PUBLIC INTEREST REVIEW FOR GROUND WATER APPLICATIONS

SUBJECT: Application G- 17749 Supersedes review of _____
Date of Review(s)

A. GENERAL INFORMATION: Applicant's Name: Eleanor Fitzgerald, Fitzgerald Ranch Inc. County: Lake

LAKE 1886
T36S/R24E-sec 33 abb
Plush-Hart Lake Area
(Taylor Ranch, Inc.)

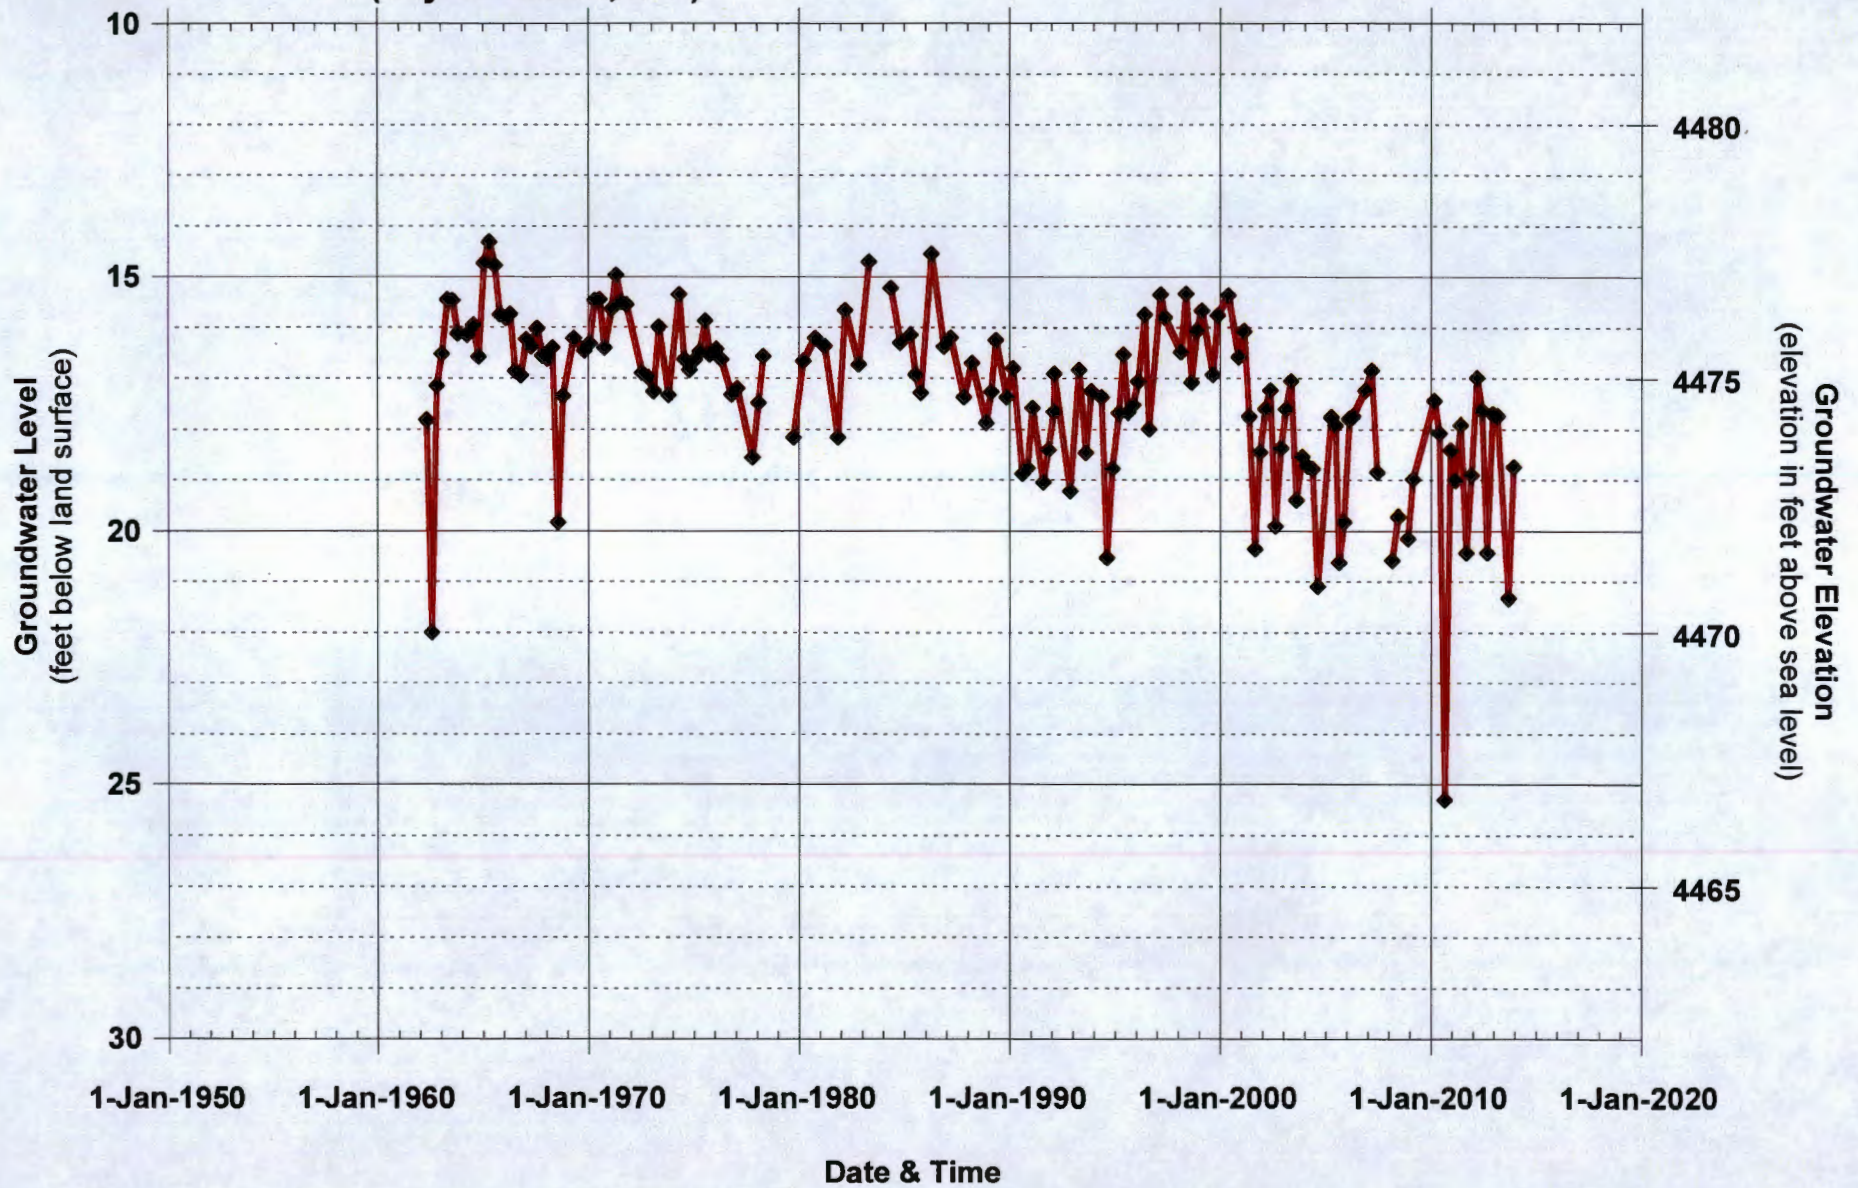
The state observation well with long term data (early 1960s to 2013) closest to the proposed POA well is state observation well 377 (well LAKE 1886) located in T36S/R24E-sec 33 abb about 2.7 miles south of the proposed POA well. The water level data for the well shows long term climate influences as well as annual seasonal influences. Before the 2000, peak annual groundwater levels were generally between 15 and 17 feet below land surface at the well. After 2001, the peak annual groundwater level has often been from 17 to 19 feet below land surface at the well. Climate may be partly to entirely responsible for the lower annual peak levels after 2001. Ongoing groundwater level measurements will help that determination.

Proposed POA to Honey Creek

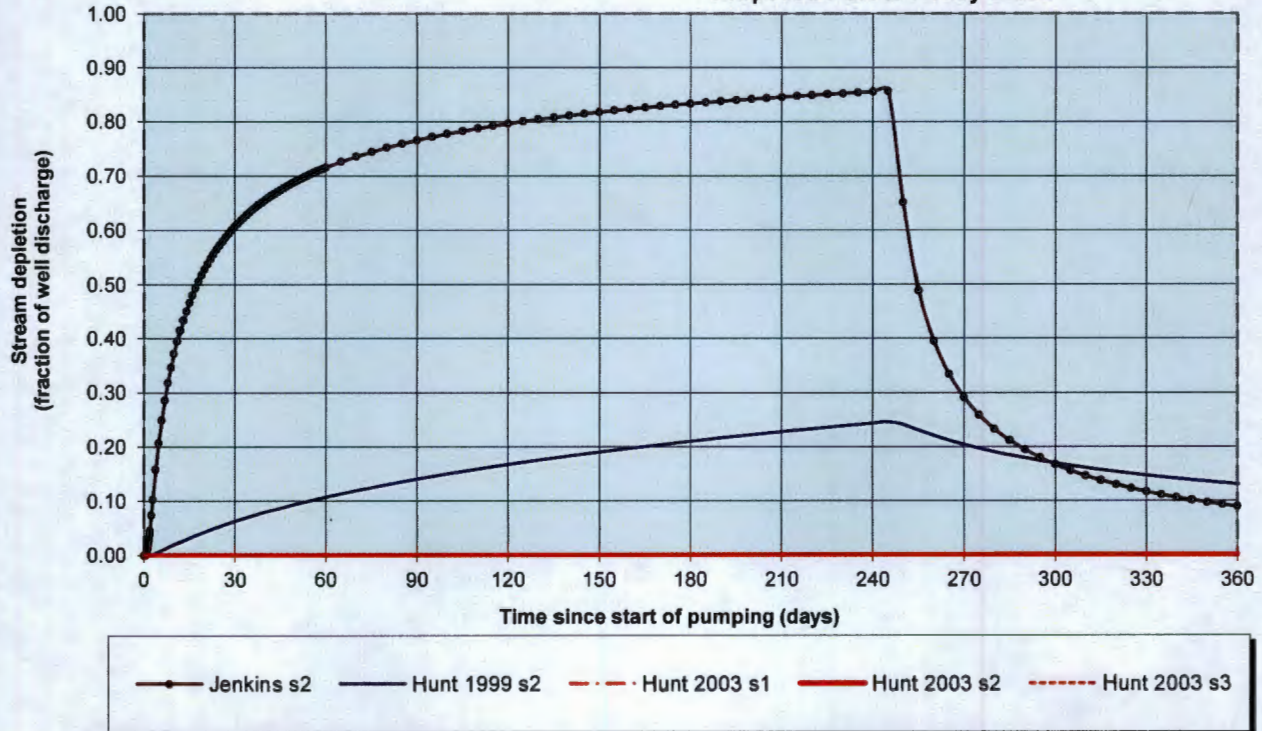
A pro-rated pumping rate of 0.98 cfs (441 gpm) was used for the pumping rate. The pro-rated rate is the maximum annual volume of water allowed (477.6 ac-ft) divided the total time (245 days). This distributes the pumping over the entire proposed irrigation season. The results of 0.00% and 0.000 cfs indicate the calculated interference was less than 0.0005 cfs.

Hunt (2003) was used to calculate the interference:
